**County of San Mateo - Planning and Building Department**

# **ATTACHMENT A**

**RECOMMENDED FINDINGS AND CONDITIONS OF APPROVAL**

Permit File Number: PLN 2014-00409

Exhibit A: *Marked-up Sheets T1 & A6*

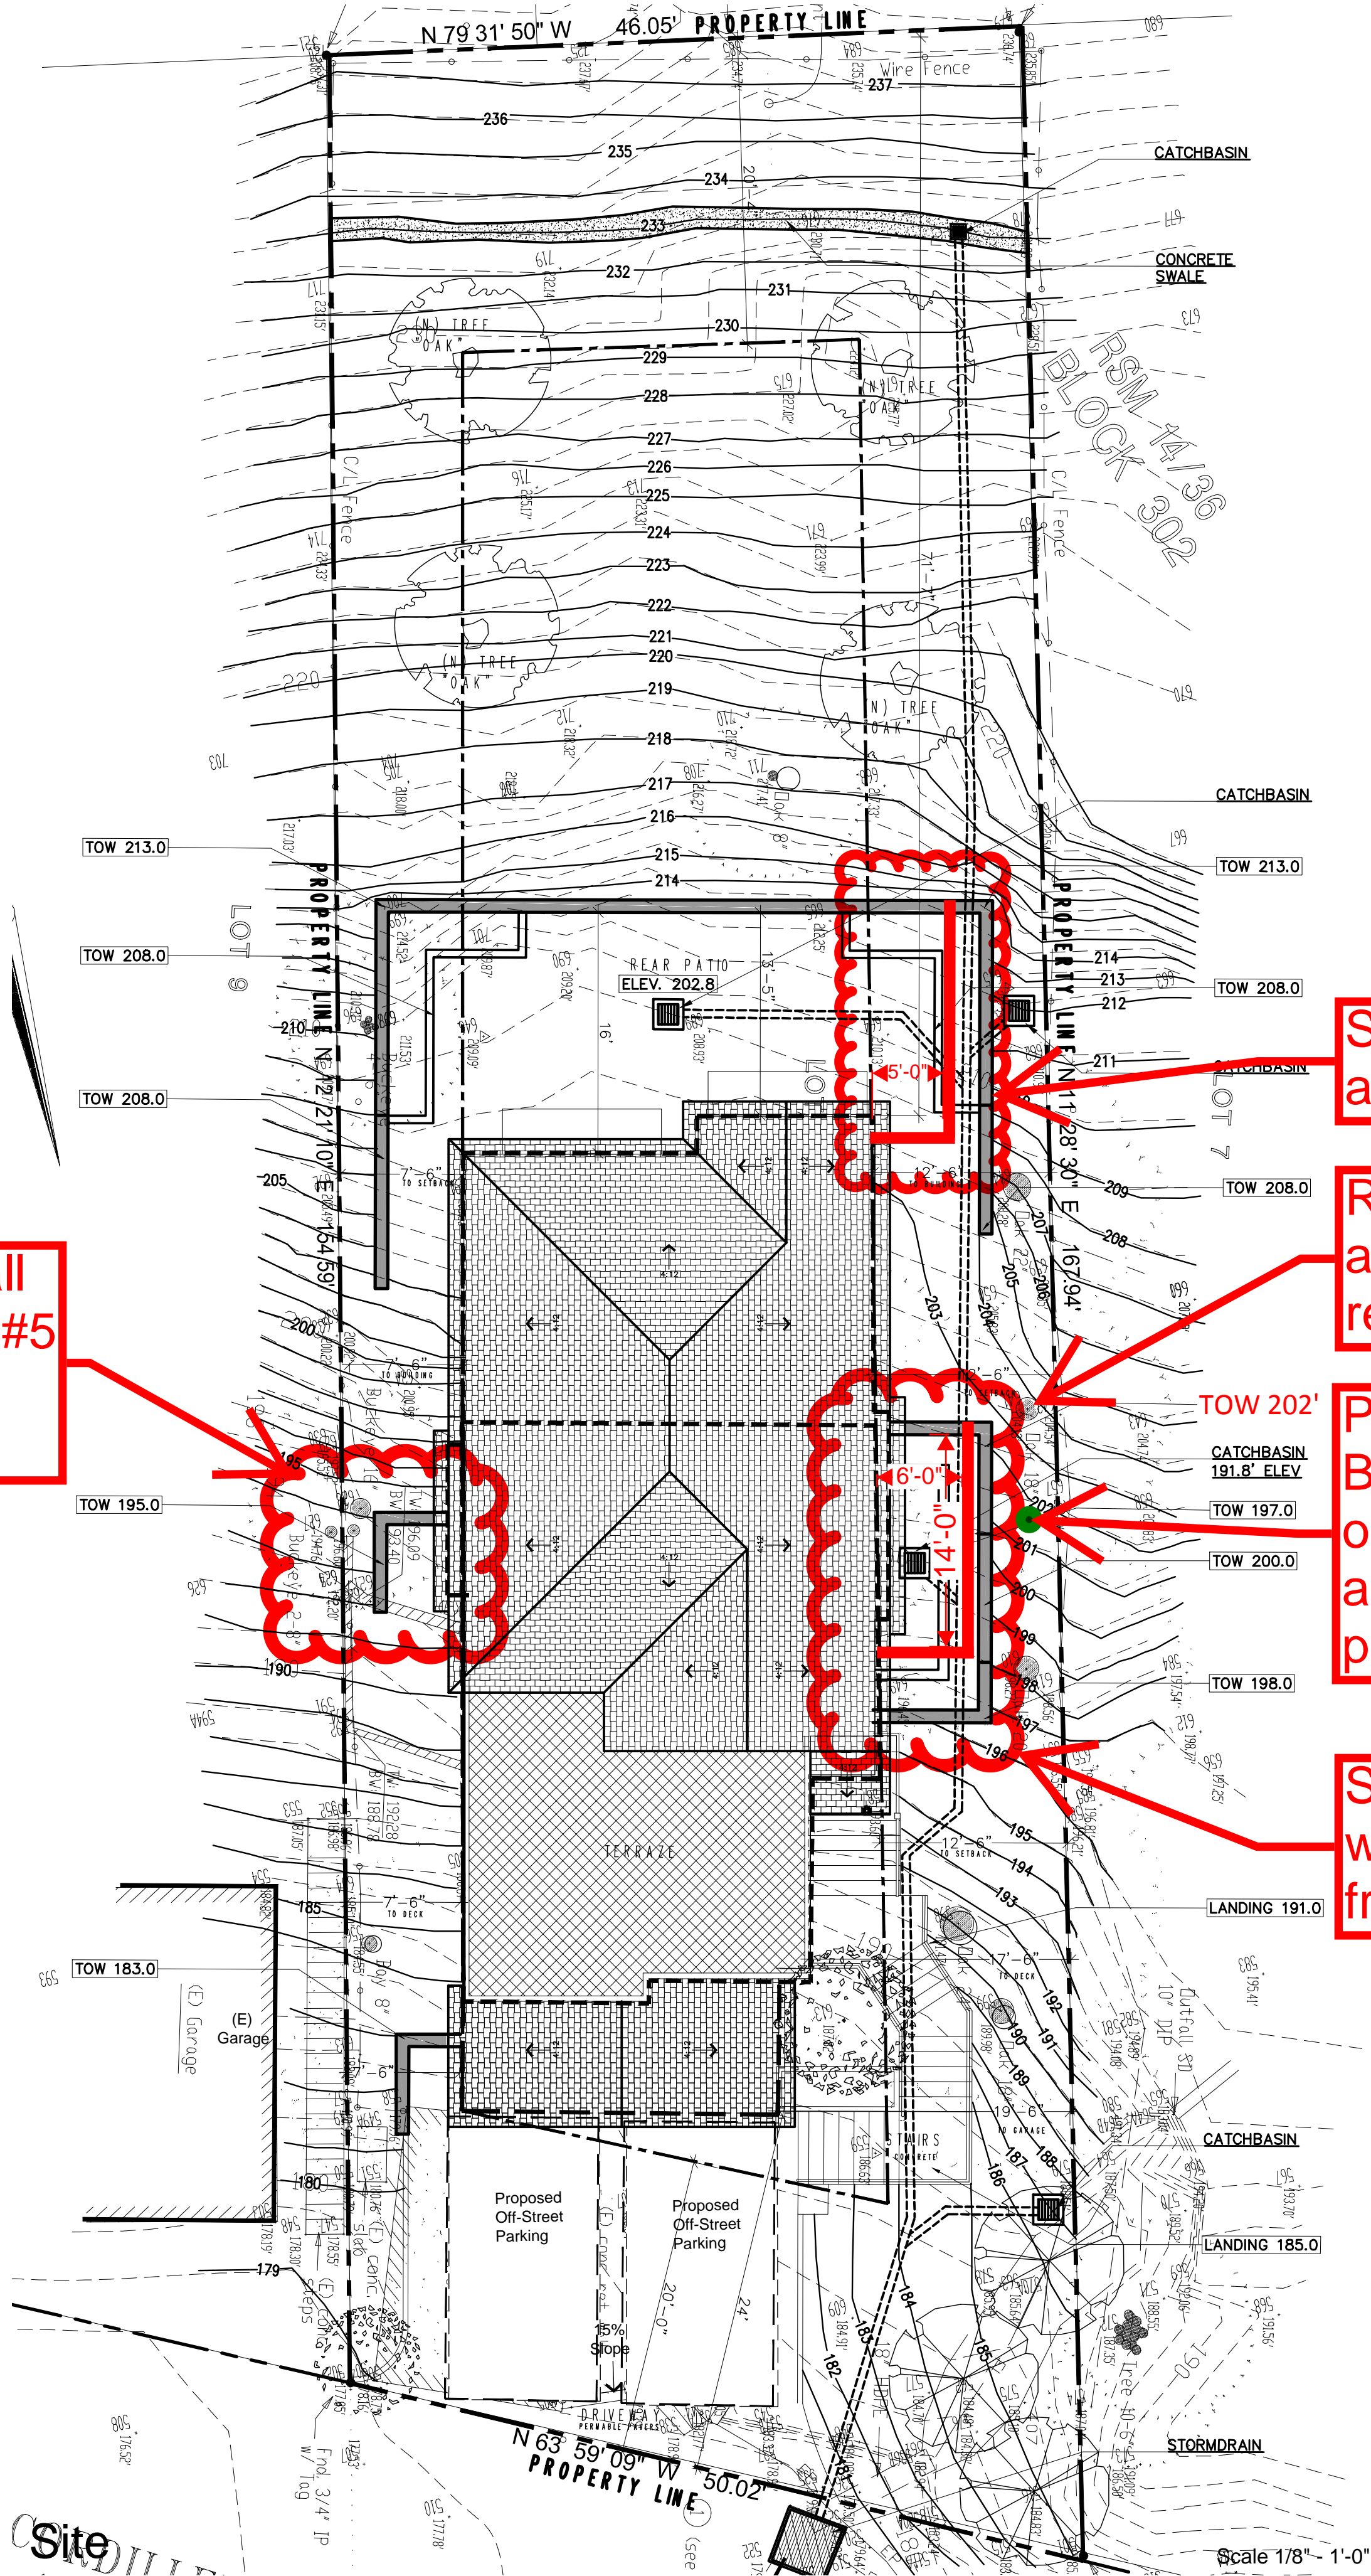
Remove retaining wall to save trees #4 and #5 to address neighbor privacy concern.

Shift retaining wall away from tree #6.
